Z-14  
(2014)

540 SOUTH GORDON ROAD  
MARIETTA GA 30126  
MEDITATION CENTER

SITE PLAN

**ZONING COMMENTS:**

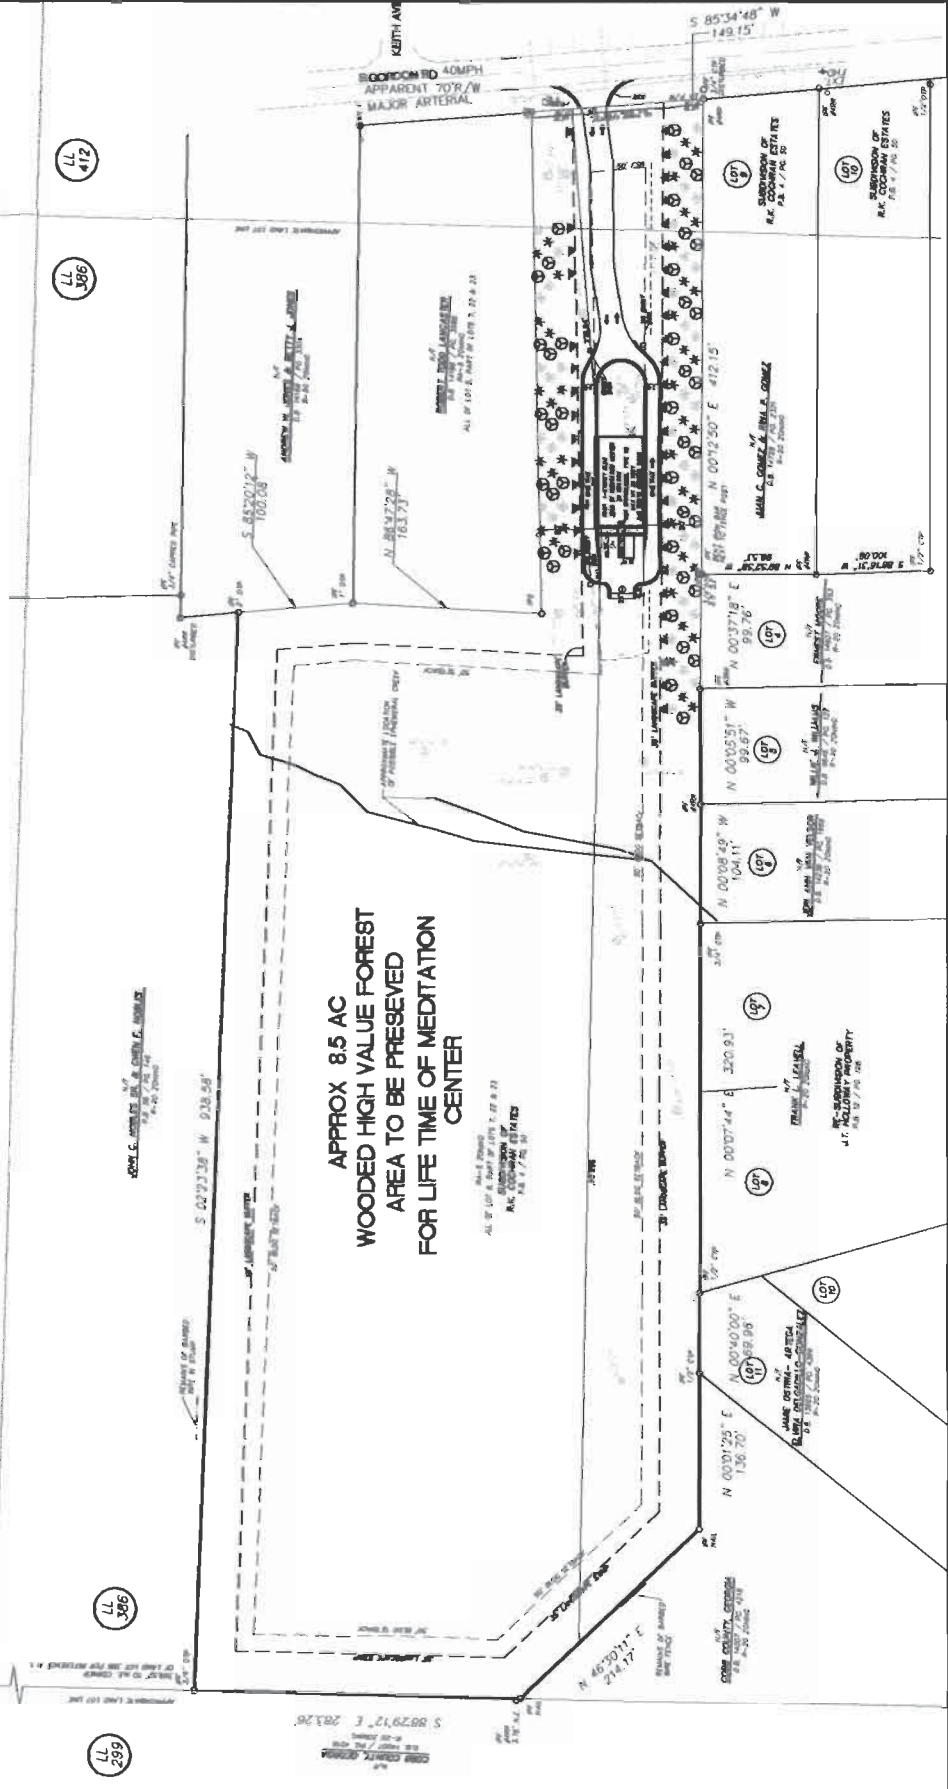
The required parking for the proposed use is one space per four seats. The site plan indicates the required five parking spaces for 20 seats.

ACCESS: Fire apparatus access roads shall extend to within 150 feet of all portions of the facility or any portion of the exterior wall of the first floor (State Modifications IFC 503.1 2006 Edition).

All access roads shall meet the American Association of State and Highway Transportation Officials (AASHTO) design manual live load standard HS20 (75,000 lbs.) with an unobstructed width of not less than 20 feet, 25 foot inside radius, 50 foot outside turning radius and unobstructed vertical clearance of not less than 13 feet 6 inches.

Dead-end access roads in excess of 150 feet shall be provided with a turn-around (IFC 503.2.5 2006 Edition). Cul-de-sac with or without an island: minimum 60-foot radius to outside curb, measured to inside of curb and a minimum lane width = 24 feet (Cobb County Development Standard 401.09). Single-Family cul-de-sac without island: 38-foot outside radius with island reverts to commercial dimensions. Hammerhead turn-around: total of 110 feet needed (45 feet + 20 feet wide roadway + 45 feet).

HYDRANT: Show fire hydrants arranged to have a hydrant available for the distribution of hose to any portion of any building on premises at distances not exceeding 500 feet (driving distance). Hydrants shall be at least 40 feet from the building (steamer connection facing street) (NFPA 24-7.2.3). Fire hydrants shall be spaced not more than 500 feet apart. Hydrants shall not be connected to water lines on the positive side (discharge side) of a fire pump. Minimum 8” supply lines to all hydrants.

- No Stormwater controls shown \_\_\_\_\_
- Copy of survey is not current – Additional comments may be forthcoming when current site conditions are exposed.
- No site improvements showing on exhibit.

South Gordon Road is classified as a major collector and according to the available information the existing right-of-way does not meet the minimum requirements for this classification.

Recommend applicant consider entering into a development agreement pursuant of O.C.G.A. 36-71-13 for dedication of the following system improvements to mitigate traffic concerns: a) donation of right-of-way on the north side of South Gordon Road, a minimum of 40' from the roadway centerline.

Recommend applicant verify that minimum intersection sight distance is available for ingress and egress maneuvers for the site if it is not, implement remedial measures, subject to the Department's approval, to achieve the minimum requirement of 445'.

Recommend sidewalk along the South Gordon Road frontage.

Recommend a paved commercial driveway.

- Site plan received by the Zoning Division on February 6, 2014, with the District Commissioner approving minor modifications;
- Fire Department comments and recommendations;
- Water and Sewer Division comments and recommendations;
- Stormwater Management Division comments and recommendations;
- Department of Transportation comments and recommendations; and
- Owner/developer to enter into a Development Agreement pursuant to O.C.G.A. §36-71-13 for dedication of system improvements to mitigate traffic concerns.

**COBB COUNTY ZONING CASE: Z-163**

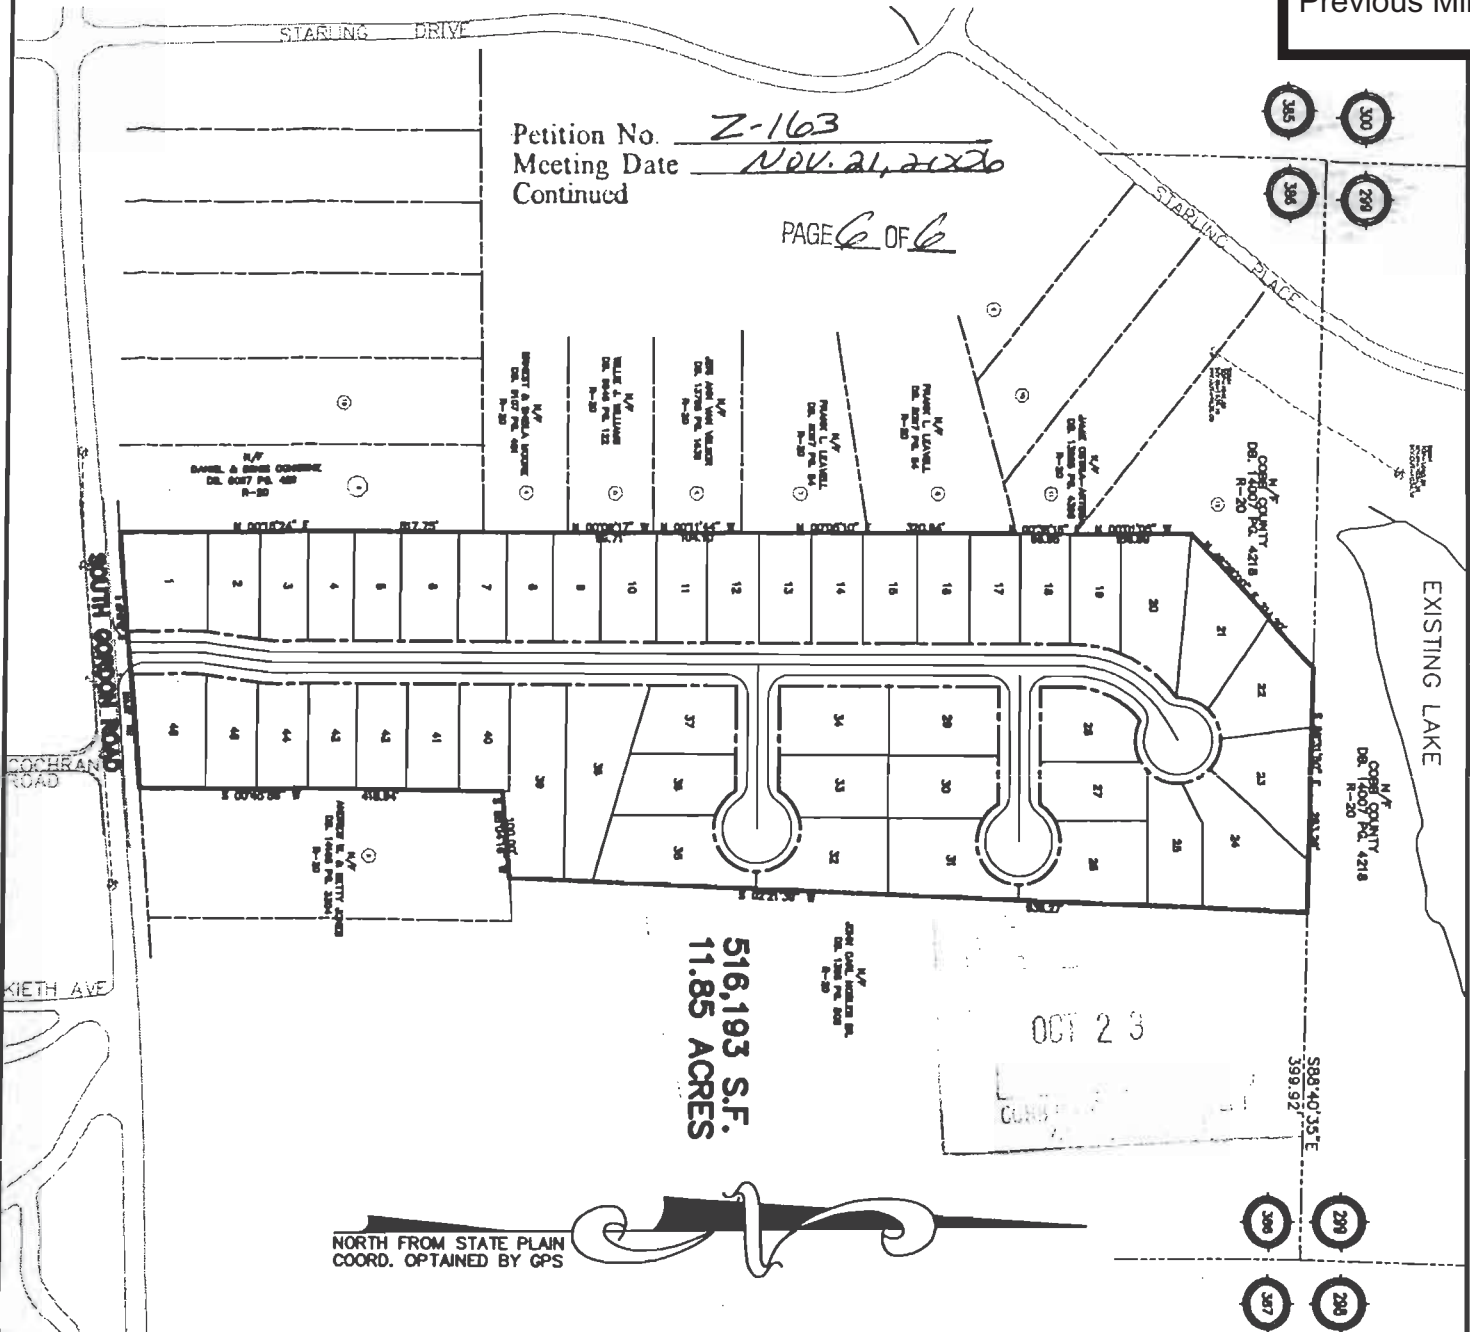
- No Stormwater controls shown for southern portion of site - **must be addressed at Plan Review.**
- Copy of survey is not current - Additional comments may be forthcoming when current site conditions are exposed.

1. This site drains generally to the northwest via two fairly well-defined channels through existing residential parcels for the southern half of the site and via overland flow into an existing lake owned by Cobb County for the northern half of the site.

2. A single stormwater management facility is proposed at the northwestern corner of the site. The pond lot provided does not appear large enough to provide adequate detention for the entire site. It may be possible to utilize the existing downstream Cobb County lake for detention if a suitable agreement can be reached with the County. However, if an agreement cannot be negotiated additional area for detention will likely be required. Also, unless a significant portion of the southern half of the site and upstream offsite drainage area can be intercepted and conveyed directly to the proposed detention facility additional ponds may be required at Lots 2 and 11 to meet downstream discharge limitations.

3. The extensive existing tree stand and undergrowth provide significant air/water quality, soil stabilization and storm flow mitigation benefits for this watershed. Construction of this project will eliminate the vast majority of this vegetation and increase pavement, storm runoff and non-point source pollution. To compensate, the First Flush Water Quality Best Management Practice Requirements must be elevated to the 1.5-inch rainfall event and each larger storm discharge controlled not to exceed the allowable discharge of the next lower, more frequent storm event (ie. 5-year storm event released at 2-year rate; 10-year event at 5-year rate; etc. to 100-year event at 50-year rate).

As necessitated by this development for egress from South Gordon Road, a deceleration lane and a left turn lane will be required.

Install sidewalk, curb and gutter along the road frontage.
